**CITY PLAN COMMISSION****THURSDAY, OCTOBER 24, 2024****FILE NUMBER:** S234-073R**SENIOR PLANNER:** Hema Sharma**LOCATION:** Buckner Boulevard/ State Highway Loop No. 12 at Hermosa Drive, west corner**DATE FILED:** September 26, 2024**ZONING:** R-10(A)**CITY COUNCIL DISTRICT:** 9**SIZE OF REQUEST:** 6.51-acres**APPLICANT/OWNER:** LA Jolla Drive, LLC

**REQUEST:** An application to revise a previously approved preliminary plat (S234-073) to replat a 6.51-acre tract of land containing all of Lots 1 and 2 in City Block E/5313 to create a 15-lot shared access development with lots ranging in size from 0.38-acre (16,604.44 square feet) to 0.54-acre (23,360.24 square feet) on property located on Buckner Boulevard/ State Highway Loop No. 12 at Hermosa Drive, west corner.

**SHARED ACCESS DEVELOPMENT**  
 REVISED PLAN  
 LOTS 1-15, BLOCK 7/5313  
 BRING A REPAIR OF LOTS 1 & 2  
 RELATED SCENE SHARIT, ASSISTANT No. 1342  
 CITY PLAN FILE NO. S234-073R  
 ENGINEERING NUMBER 07-2024-073R

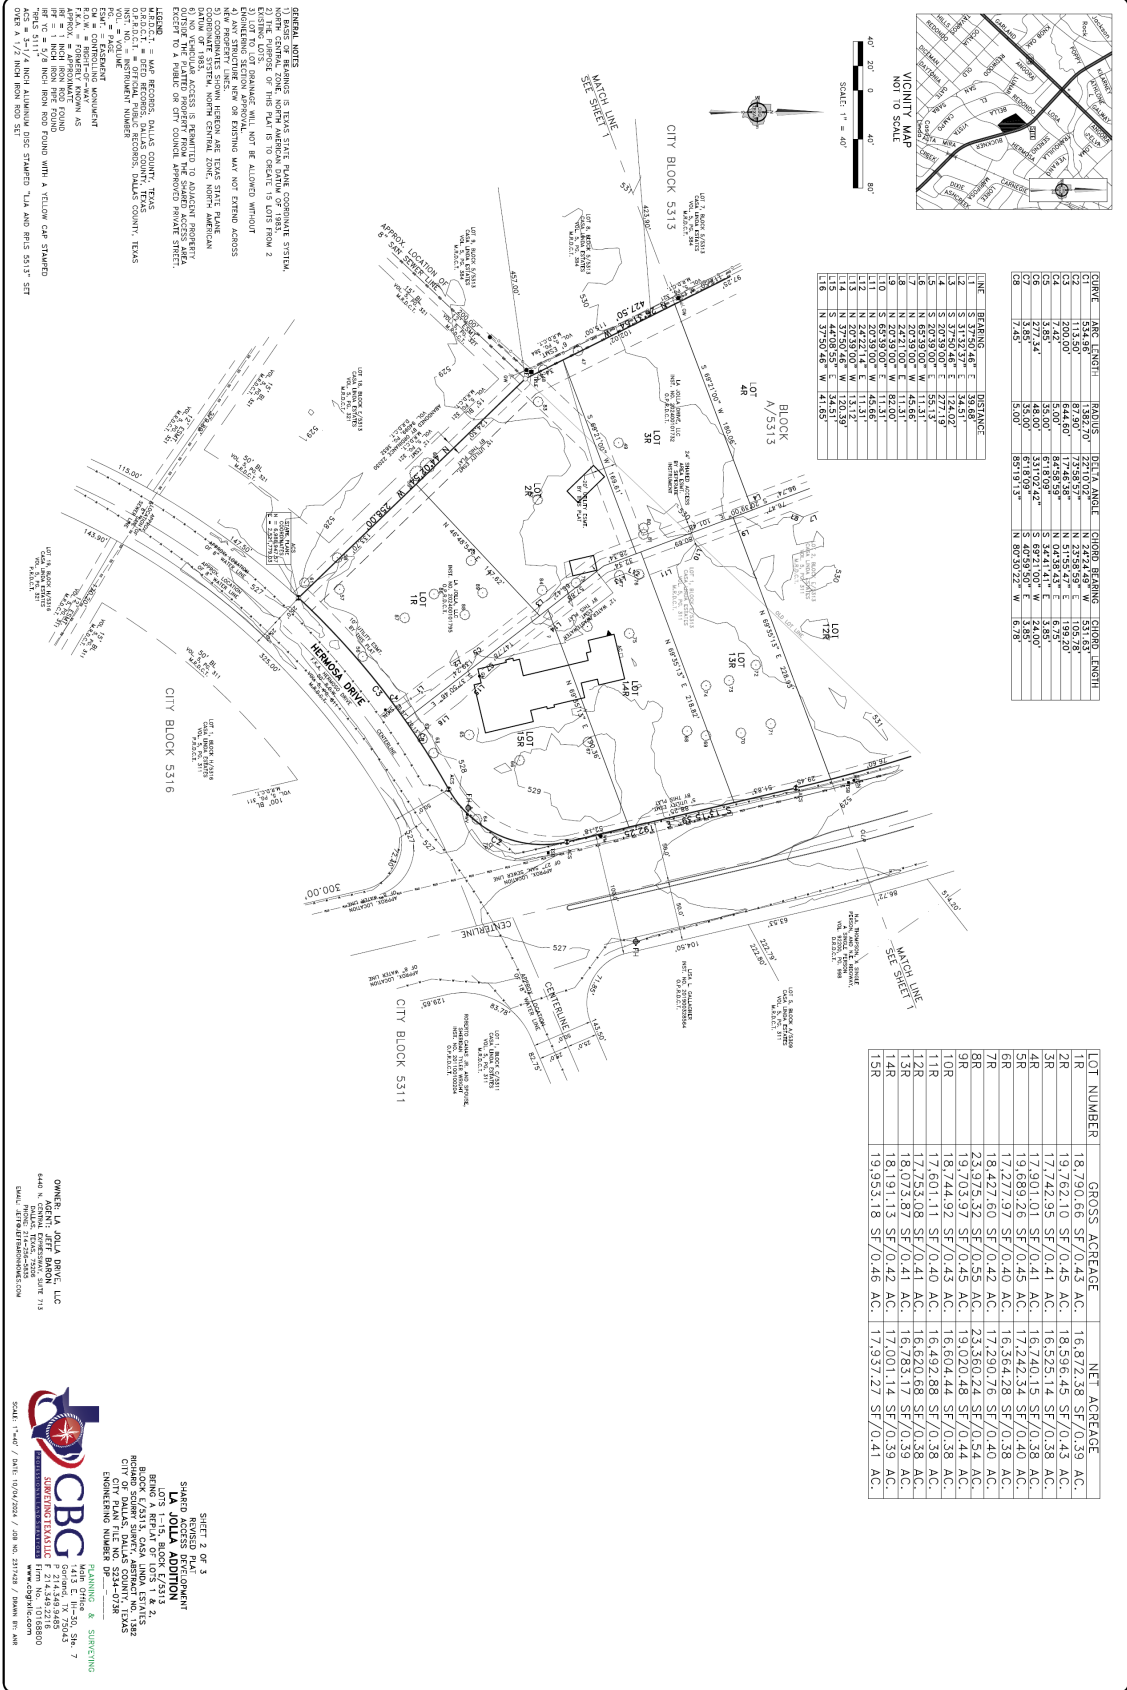
7. On the final plat, include two boundary corners tagged with these coordinates: "Texas State Plane Coordinate System, North Central Zone, North American Datum of 1983 on Grid Coordinate values, No Scale and no Projection."

8. On the final plat, monument all set corners per the Monumentation Ordinance. Prior to submittal of the final plat for the Chairman's signature. The monuments must be verified by the Chief City Surveyors Office in the Public Works Department. *Section 51A-8.617*

16. On the final plat, dedicate 53.5 feet of right-of-way (via fee simple) from the established center line of Buckner Boulevard/ State Highway Loop No. 12. *Section 51A 8.602(c)*
17. On the final plat, dedicate 28 feet of right-of-way (via fee simple or street easement) from the established centerline of Hermosa Drive. *Sections 51A-8.602(c), 51A-8.604(c) and 51A-8.611(c).*
18. On the final plat, dedicate a minimum 10-foot by 10-foot corner clip (via fee simple or street easement) at the intersection of Buckner Boulevard/ State Highway Loop No. 12 & Hermosa Drive. Section 51A 8.602(d)(1)
19. A larger corner clip may be requested during engineering plan and traffic review to accommodate an adequate turning radius, or to maintain public/traffic appurtenances, within the area of the corner clip. *Section 51A 8.602(d)(1), 51A 8.608(a)*

20. Provide additional shared access area easement, up to 26 feet, for compliance to Dallas Fire Code when building height is 30 feet or greater.
21. A water and wastewater easement at least 12 feet wide to be used exclusively for public water and wastewater below grade must be provided within the Shared Access Area Easement & labeled on the plat. Section 51A-4.411(d)(2) and Sections 49-60(d), 49-61(c)(5)(B), and Development Design Procedure and Policy Manual Section 6.2

27. Include the words “Shared Access Development” in the title block of the final plat. Platting Guidelines
28. Place a note on the final plat stating: “No vehicular access is permitted to adjacent property outside the platted property from the shared access area except to a public or City Council approved Private Street.” Section 51A-4.411(d)(3), and 51A-4.411(d)(10)

29. If a guard house is provided, it must be at least 30 feet from the shared access point. Section 51A-4.411(d)(8)
30. The Shared Access Area Easement must be terminated a minimum of 3 feet from the adjacent property or right-of-way. Section 51A-8.618(b)

31. Provide guest parking at a rate of 0.25 spaces per dwelling unit and with adequate maneuverability per the Shared Access Development requirements.

32. Prior to final plat, submit a completed final plat checklist and all supporting documents.
33. On the final plat, provide 3 feet barrier easement along thoroughfare.
34. On the final plat, clarify shared access area easement.
35. On the final plat, verify topographic data.

40. Prior to final plat, compliance with City’s street lighting standards including illumination standards, material, installation, and activation per Street Design Manual.
41. On the final plat, please update all references to abandonments to the following standard language: “Abandonment authorized by Ordinance No. \_\_\_\_\_, recorded as Inst. No. \_\_\_\_\_. (Note: Vol. Page can be used in place of Instrument No. as needed)
42. Prior to final plat, provide documentation for “FKA Hermoso Drive”. Section 51A-8.403(a)(1)(A)(xii)
43. On the final plat, change “Buckner Boulevard” to “Buckner Boulevard/ State Highway Loop No. 12”. Section 51A-8.403(a)(1)(A)(xii)
44. On the final plat, identify the property as Lots 1 through 15 in City Block E1/5313.
